Oxford Knit Composite Ltd. (Extension)

24 June 2025

Observation-1: Mismatches in as-built drawings (Building-5).

Observation-3: Vehicle impact risk on column (Building-5).

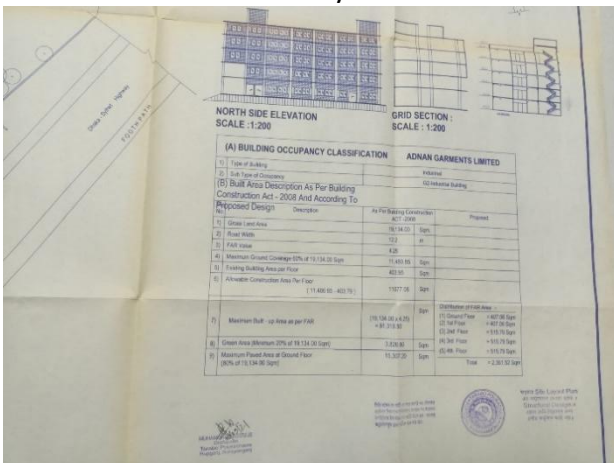
Description: Columns in the south are susceptible to vehicle impact. The factory is required to provide separate column guards to avoid vehicle impact.
